REQUEST FOR ADDITIONAL INFORMATION
REACTOR COOLANT SYSTEM VENTS (ITEM II.B.1)
SURRY POWER STATION UNITS 1 AND 2

REQUEST FOR ADDITIONAL INFORMATION

SURRY 1 & 2

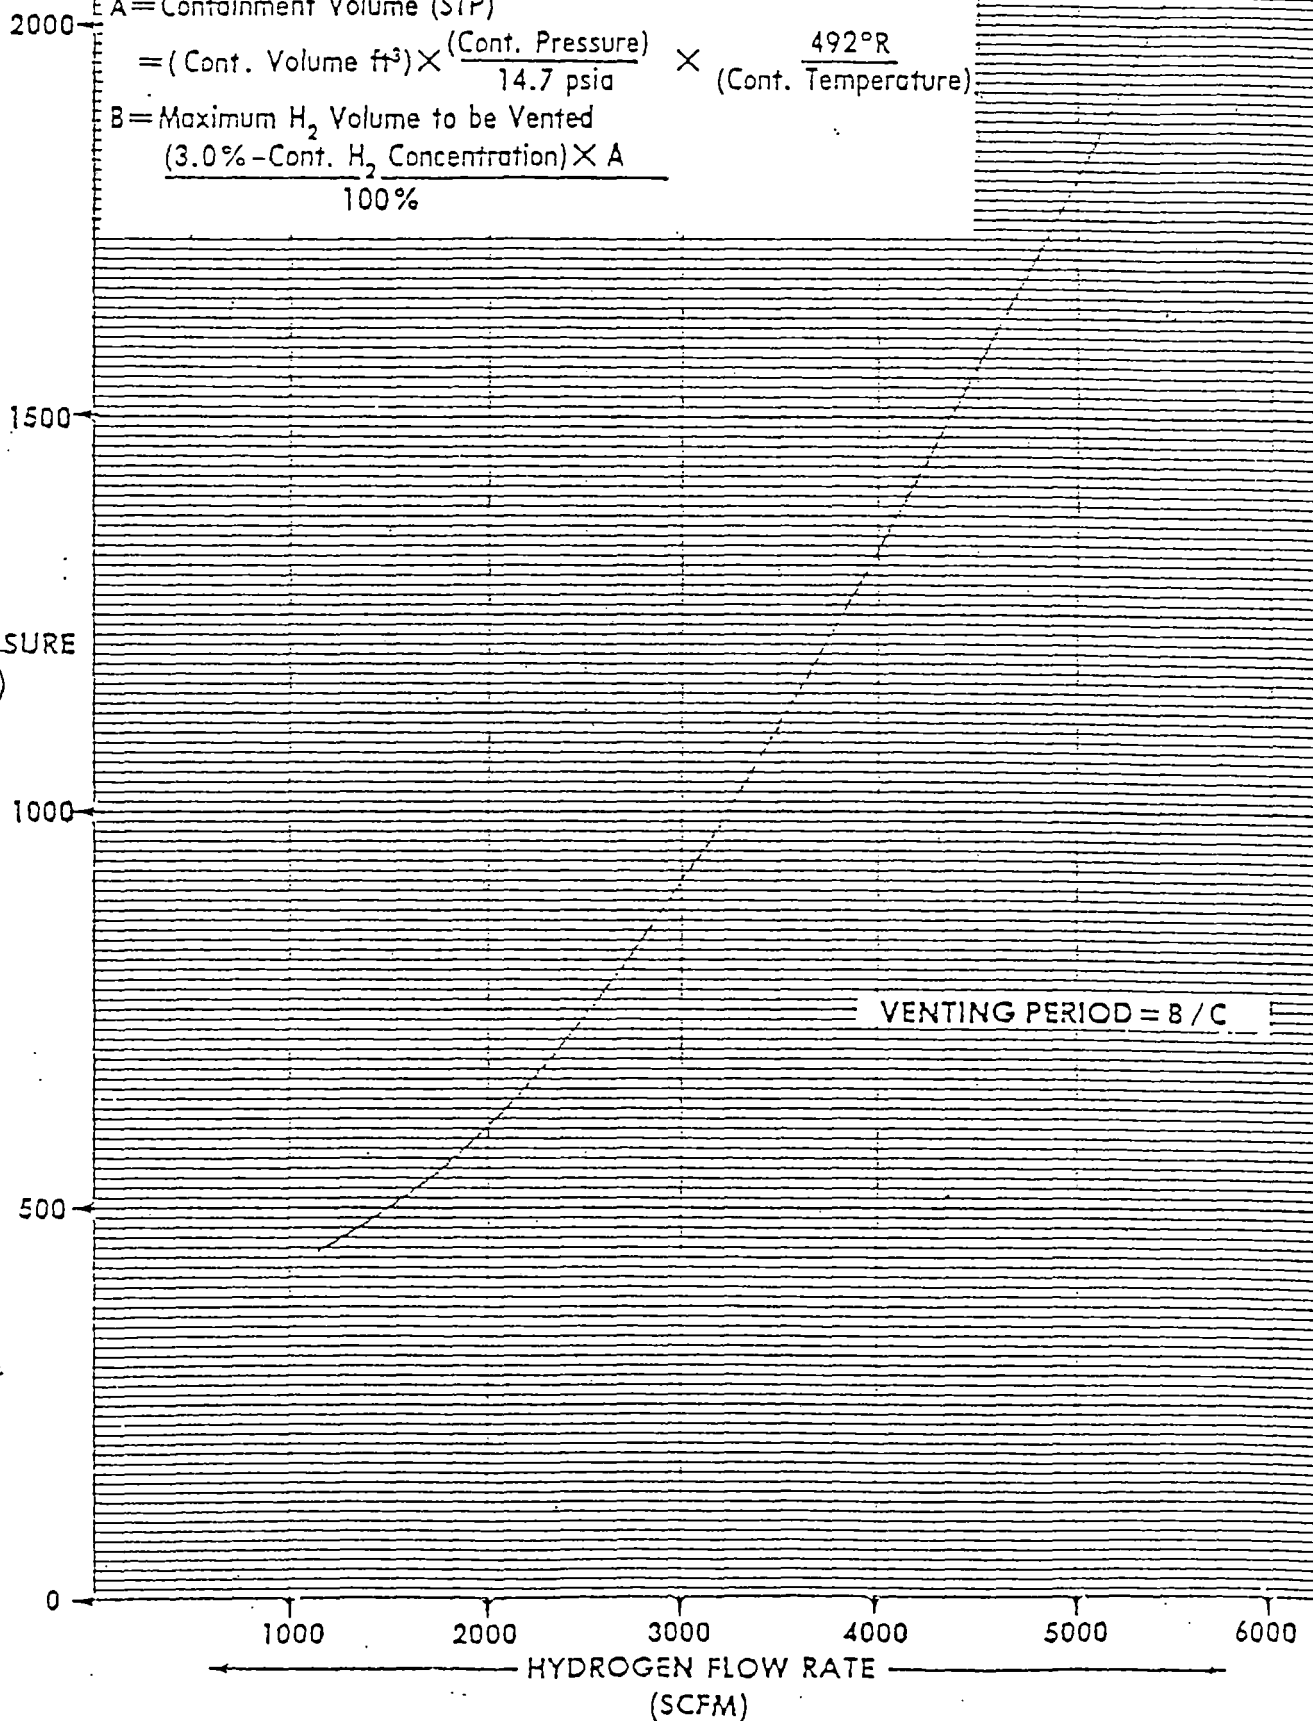
2. Demonstrate that the reactor vessel head and pressurizer venting system flow restriction orifices are smaller than the size corresponding to the definition of a loss-of-coolant accident (10 CFR Part 50, Appendix A) by providing the pertinent design parameters of the reactor coolant makeup system and a calculation of the maximum rate of loss of reactor coolant through the vent orifices (reference NUREG-0737 Item 11.B.1 Clarification A.(4)).

- a. Containment Hydrogen concentration - LESS THAN (1) %
- a. Reduce hydrogen concentration: [Enter plant specific means]
- b. Calculate maximum venting PERIOD _____ (See graph on page 5)

Note

A = Containment Volume (STP)

$$= (\text{Cont. Volume ft}^3) \times \frac{(\text{Cont. Pressure})}{14.7 \text{ psia}} \times \frac{492^\circ\text{R}}{(\text{Cont. Temperature})}$$
 B = Maximum H₂ Volume to be Vented

$$\frac{(3.0\% - \text{Cont. H}_2 \text{ Concentration}) \times A}{100\%}$$

RCS VENT SYSTEM DISCHARGE POINTS

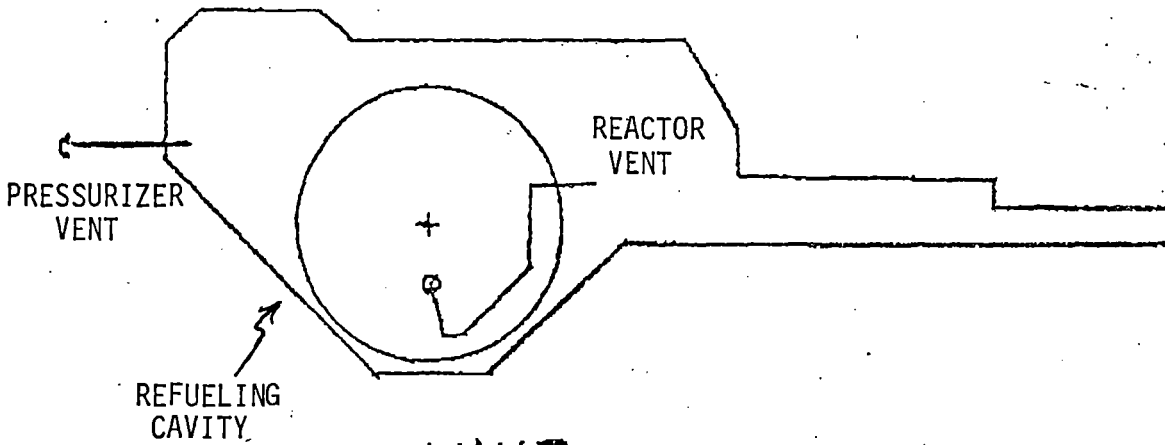
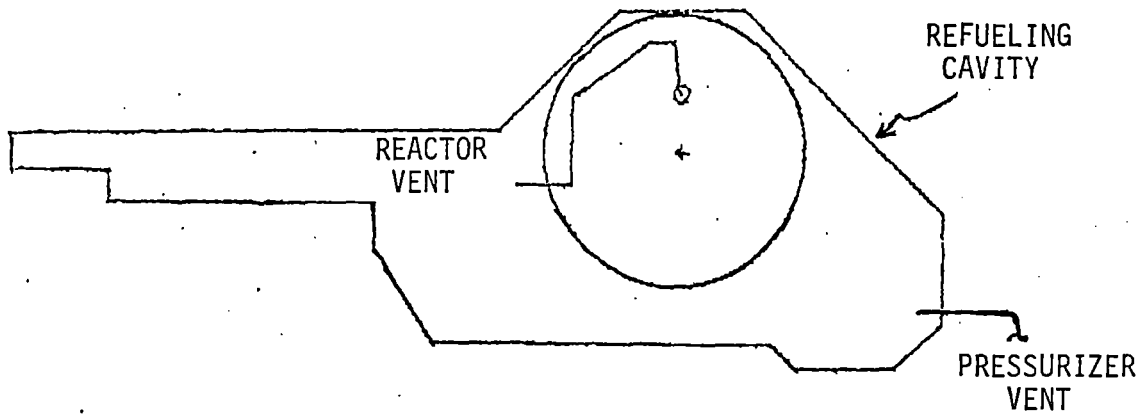
5. Verify that any nearby structures, systems, and components essential to safe shutdown of the reactor or mitigation of the consequences of a design basis accident are capable of withstanding the effects of the anticipated mixtures of steam, liquid, and noncondensable gas discharging from the reactor vessel head and pressurizer venting system.

Response: The spray from both the RCS and Pressurizer Vent Systems are directed into the refueling cavity such that they do not impinge on any components. The pressurizer vent system discharge is directed straight down into the refueling cavity. The RCS Vent System discharge is directed at a 45° angle into the refueling canal from the reactor vessel head. The attached sketch (Attachment III) details the approximate location of the vent system discharge for both units. All components in this area were originally designed or have been qualified to withstand the effect of a LOCA, therefore, no additional analysis need be performed.
